UNITED STATES PATENT AND TRADEMARK OFFICE

| APPLICATION NO. | FILING DATE | FIRST NAMED INVENTOR | ATTORNEY DOCKET NO. | CONFIRMATION NO. |
|-----------------|-------------|----------------------|---------------------|------------------|
| 10/715,670 | 11/17/2003 | Chiahua Ho | MXICP017 | 4806 |

DETAILED ACTION

FIG. 4B

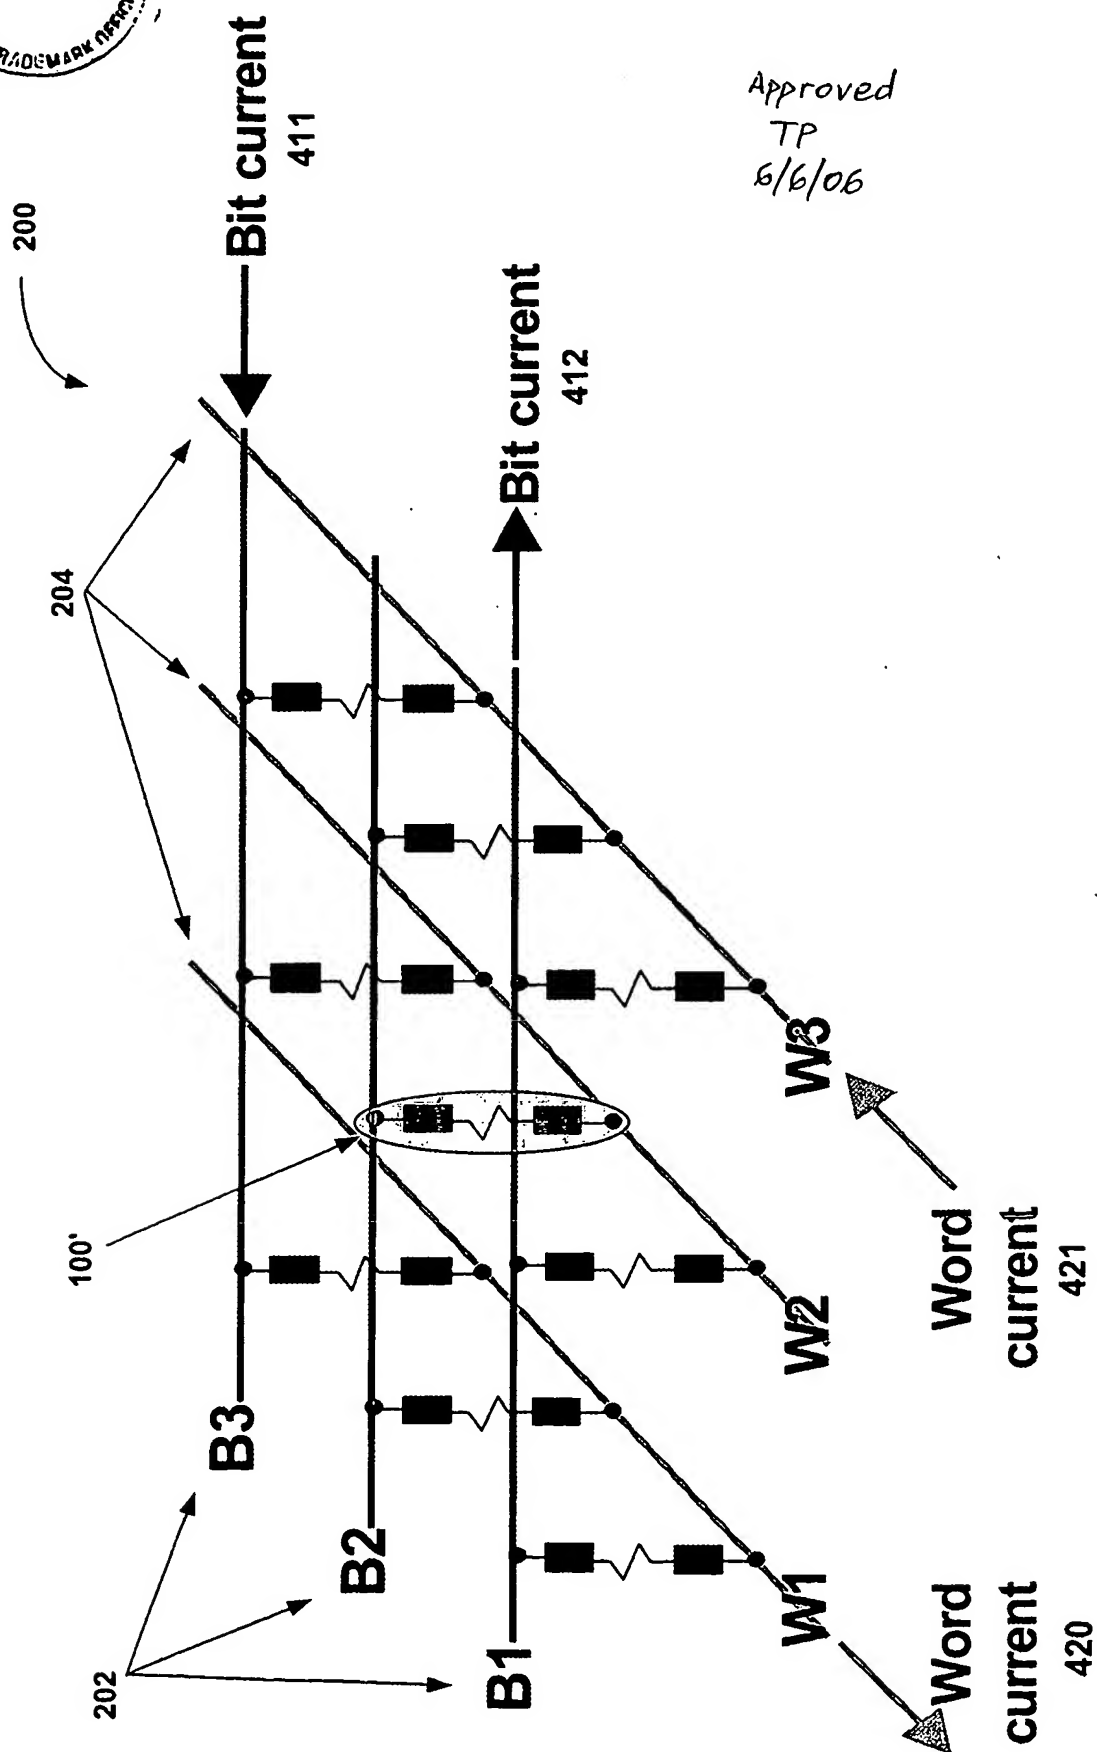
1. The drawings are objected to under 37 CFR 1.83(a). The drawings must show every feature of the invention specified in the claims. Therefore, the features as recited in claims 5-7 and 18-20 (it should be noted that Figs. 4A-B and 5 of the present invention only show the plurality of MTJ devices } each connected to the respective bit line B and word line W via u-metal without any communication with a diode as recited in claims 3 and 17); the magnetic random access memory (MRAM) cell having a magnetic junction tunnel (MTJ) device with a perpendicular magnetic orientation, the first magnetization as recited in claims 8 and 10, the second magnetization as recited in claims 9 and 11, the first-in plane component and the second-in plane component as recited in claim 13 and the first-in plane component cancels out the second-in plane component as recited in claim 14 (it should be noted that Figs. 4A-B and 5 of the present invention show the magnetic random access memory (MRAM) cell 100' represented by the O ring symbol which is totally separated with the MTJ devices) must be shown or the feature(s) canceled from the claim(s). No new matter should be entered.

Claims 5-14 and 18-20 are not vague and indefinite since they are not readable on the respective drawings of the present invention. Because Figs. 4A-B and 5 of the

present invention show the magnetic random access memory (MRAM) cell 100' represented by the O ring symbol which is totally separated with the MTJ devices.

Corrected drawing sheets in compliance with 37 CFR 1.121(d) are required in reply to the Office action to avoid abandonment of the application. Any amended replacement drawing sheet should include all of the figures appearing on the immediate prior version of the sheet, even if only one figure is being amended. The figure or figure number of an amended drawing should not be labeled as "amended." If a drawing figure
